Addendum Number Three

EMS Post #1

RFB Bid Number: 26-0035, Sedgwick County, Kansas

Issued: September 8, 2026

A5.1

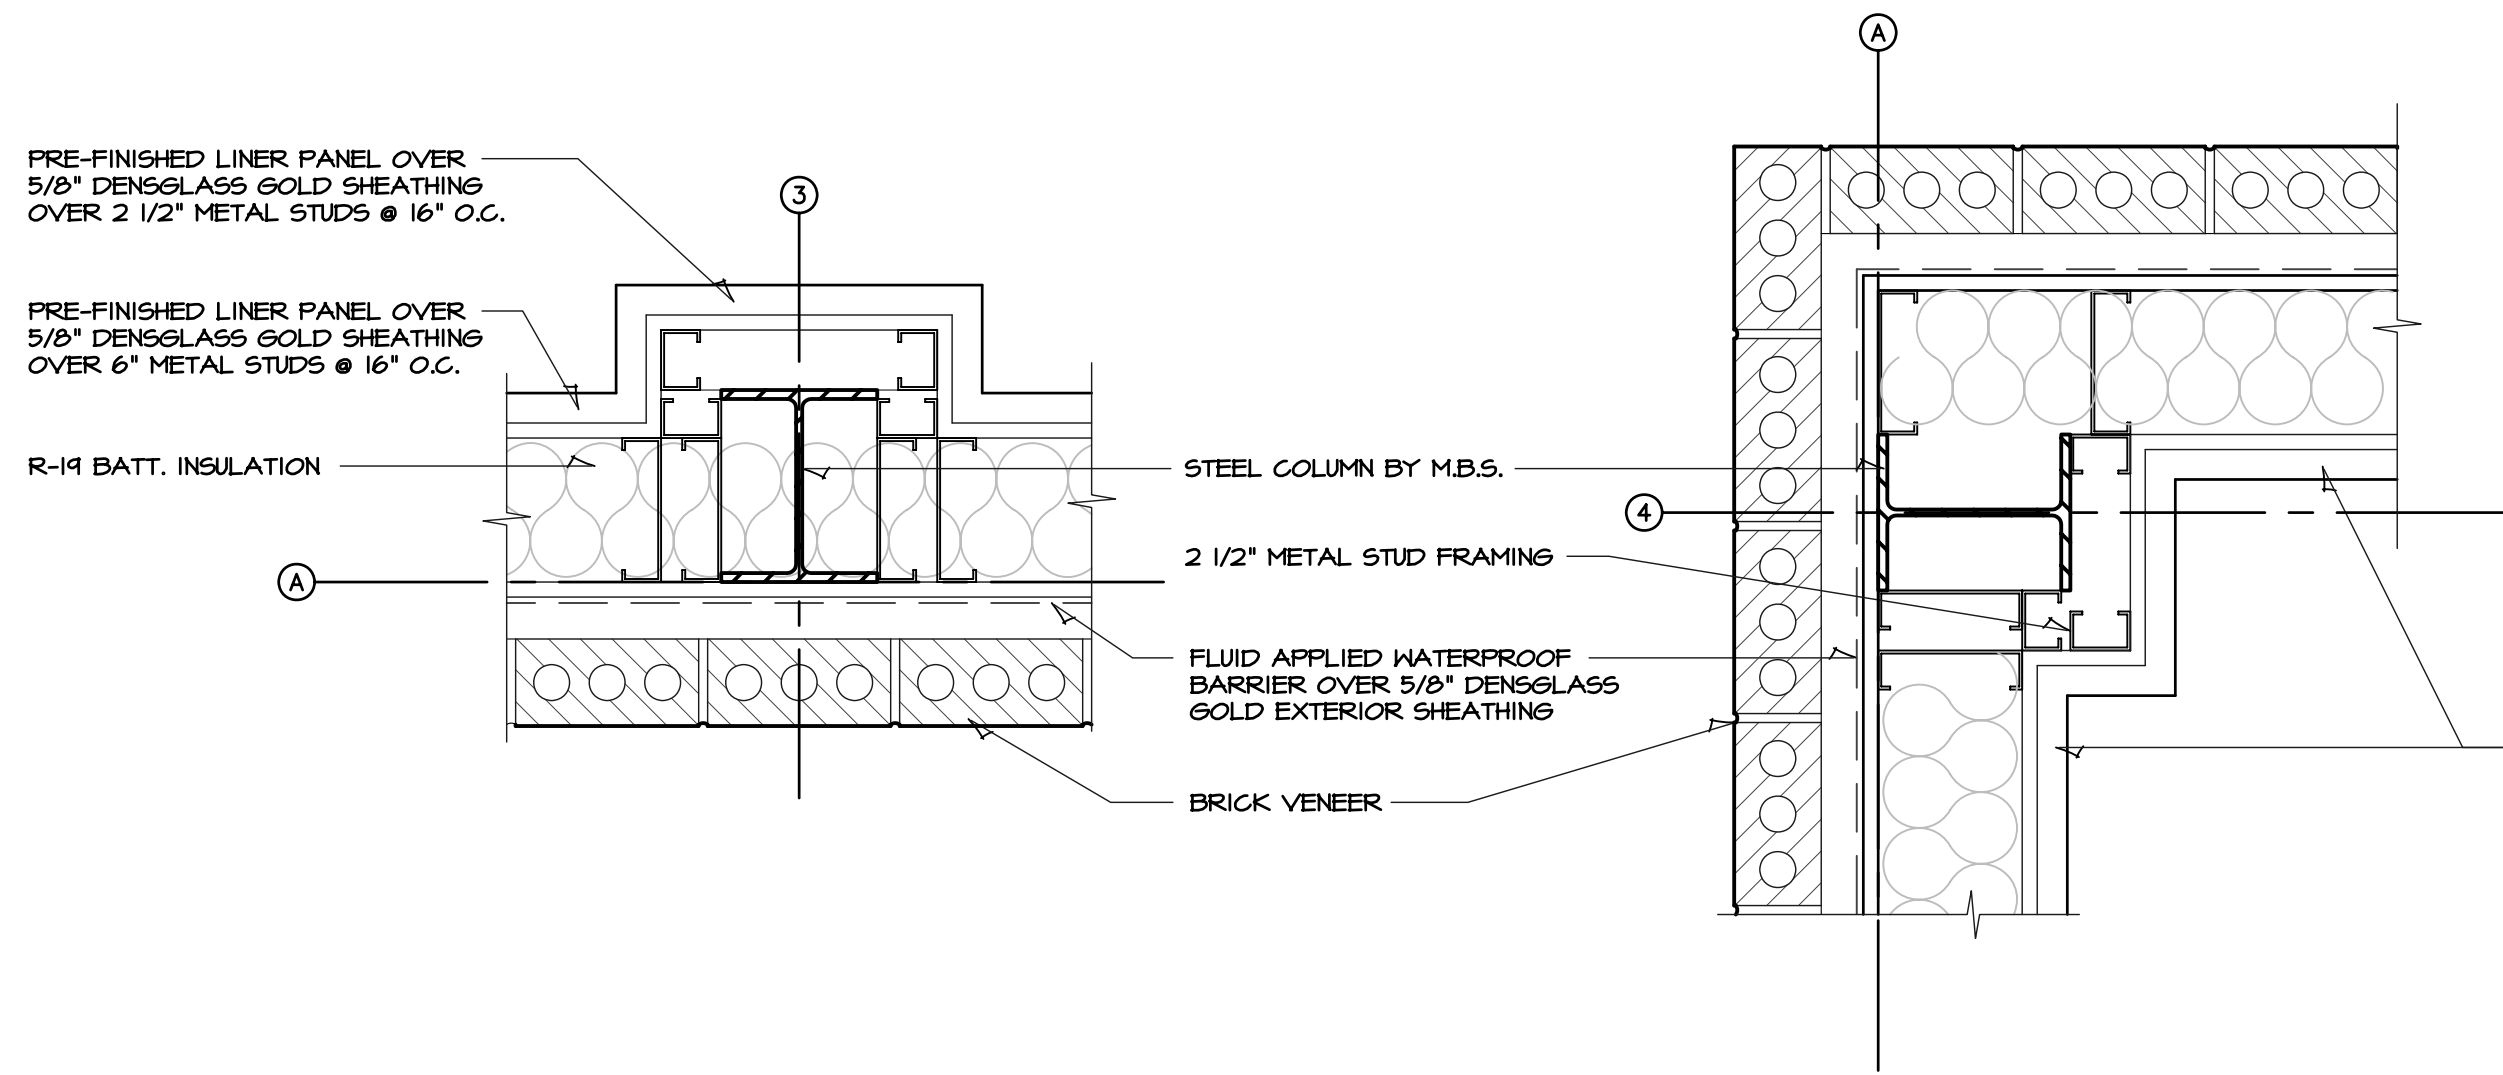
- 3.7 Sheet A5.1
The window on section 2 has been corrected to show aluminum in lieu of hollow metal. This sheet is being reissued with this addendum.
- 3.8 Sheet A5.5
The window on section 2 has been corrected to show aluminum in lieu of hollow metal. This sheet is being reissued with this addendum.
- 3.9 Sheet A5.6
The Plan Details have been revised, this sheet is being reissued with this addendum.
- 3.10 Sheet A6.4
a. There are a couple of references to this sheet, those references shall be deleted.

SHEET
S100
OF 1 SHEETS

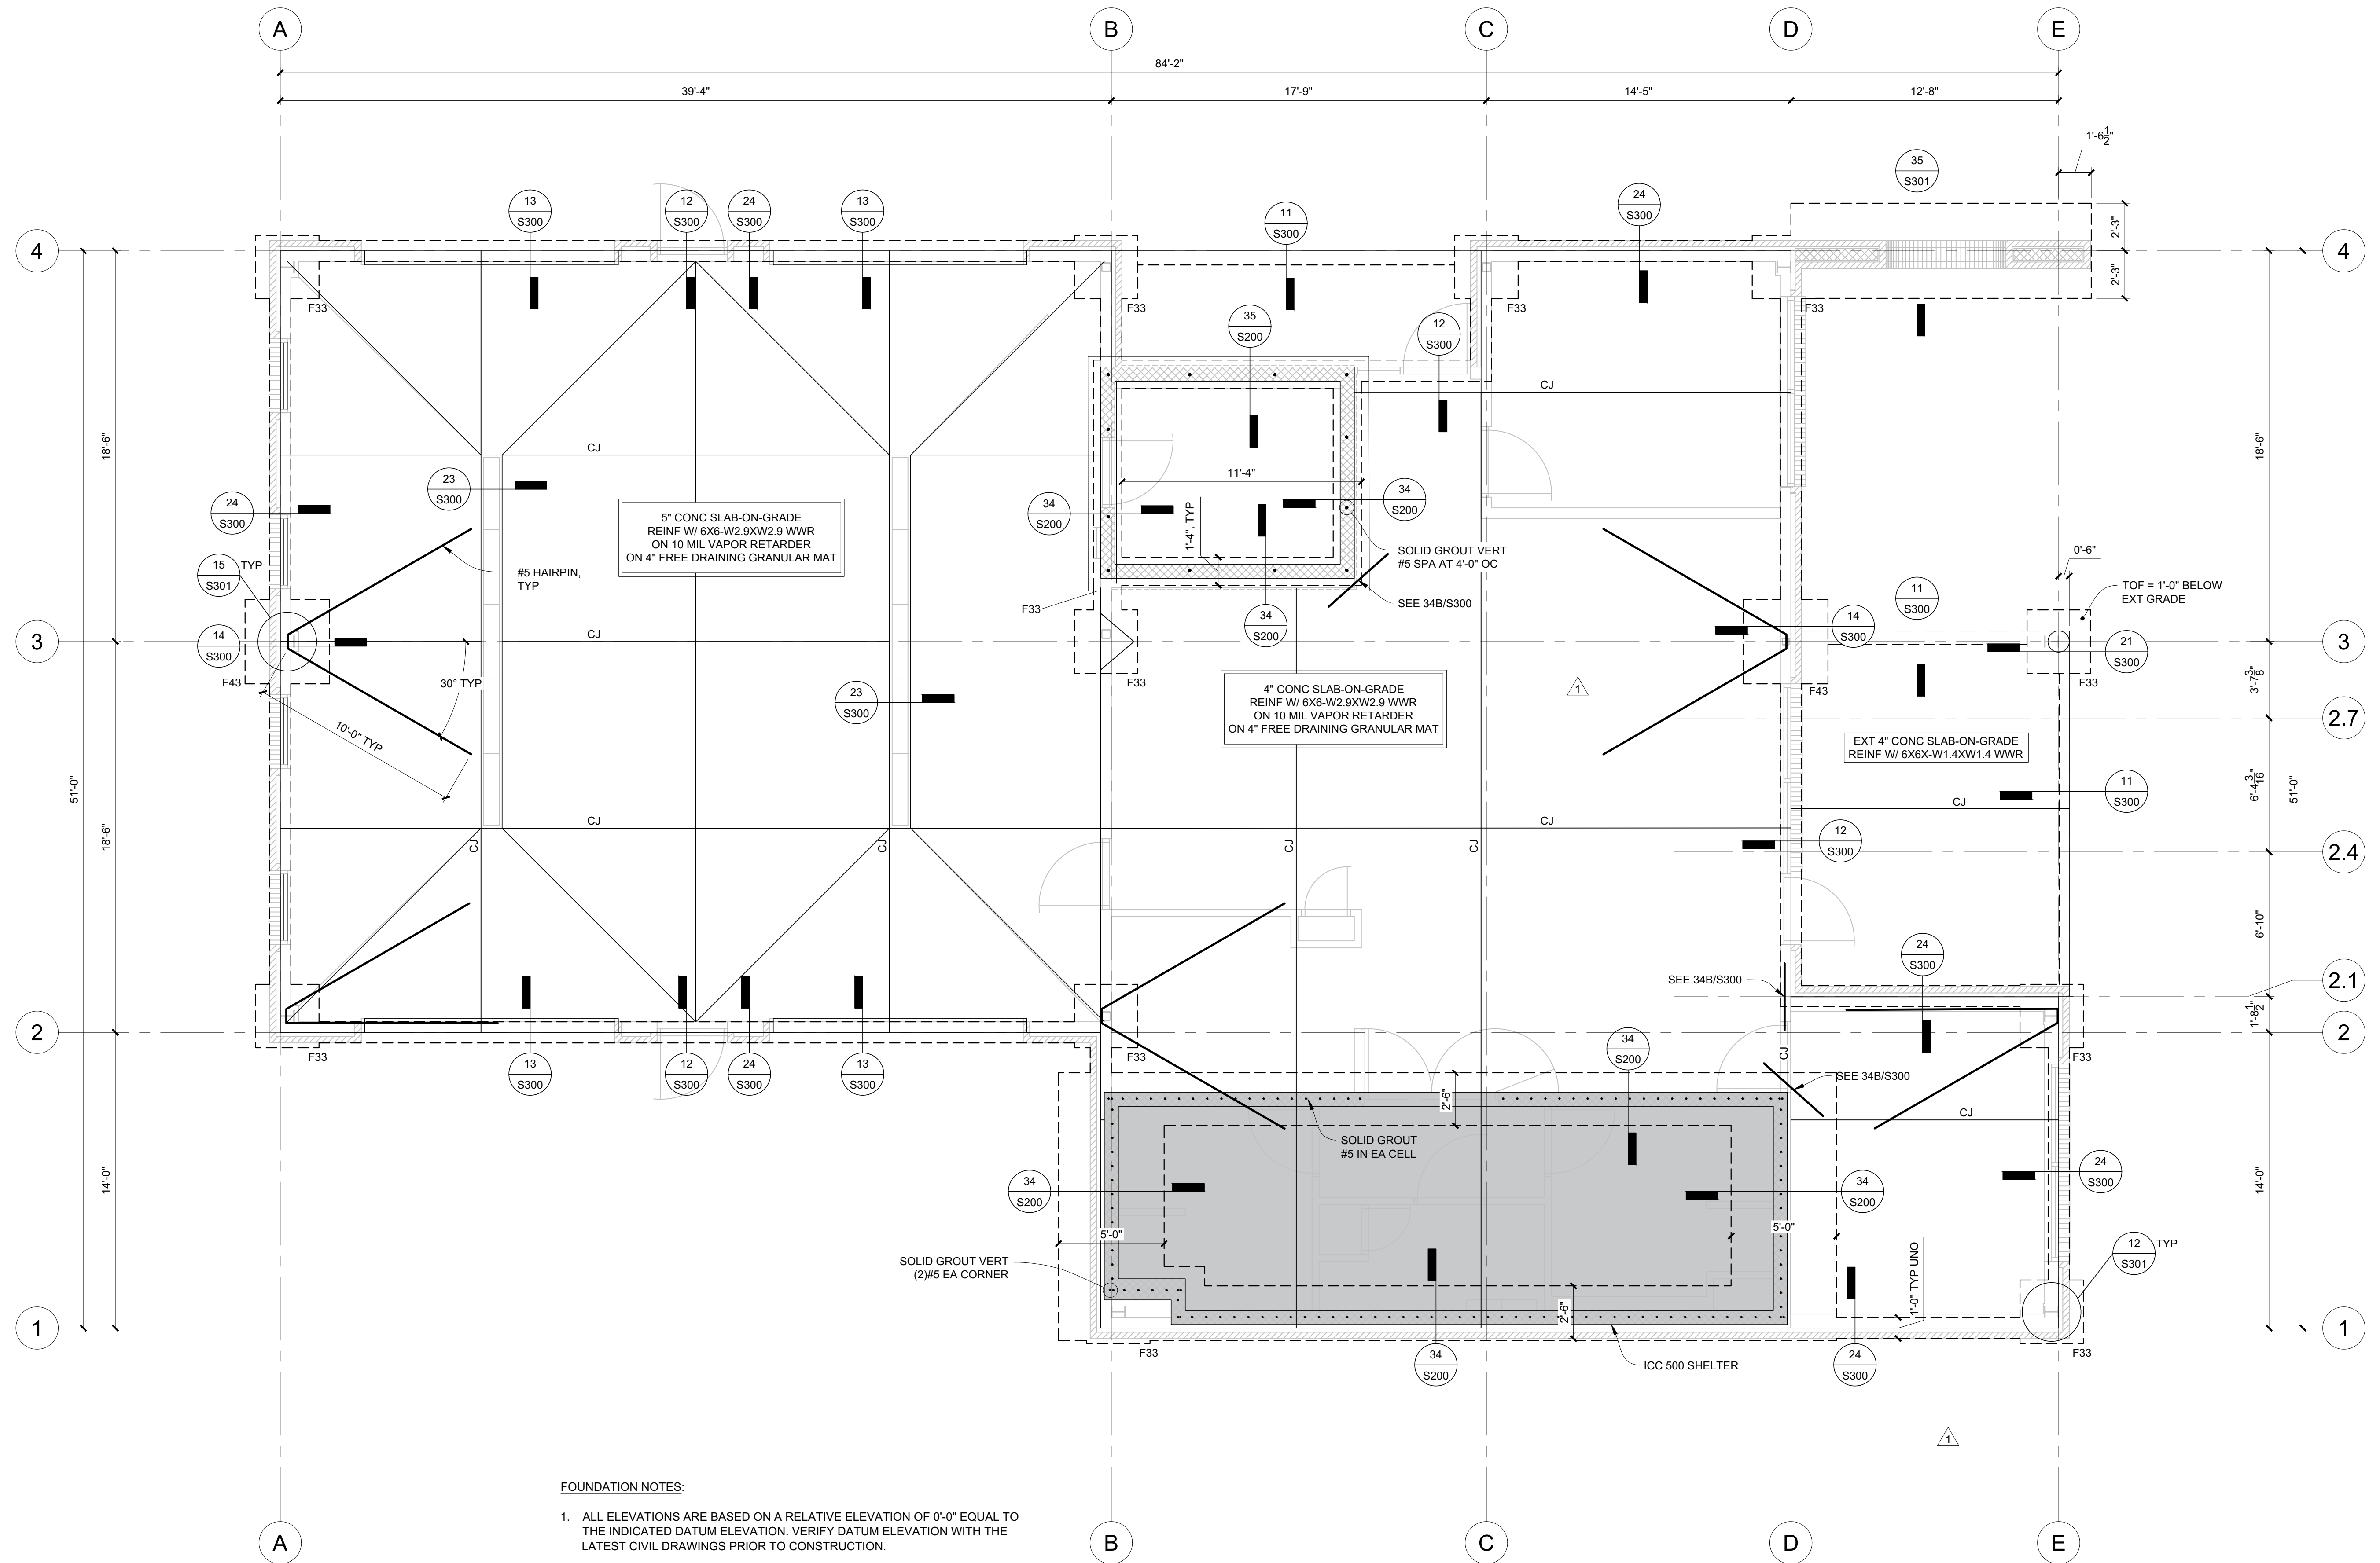
- 3.12 Sturctural Sheets S001, S100, S200, S201, S300, and S301
There have been several corrections to this sheet.
This sheet is being re-issued with this Addendum.
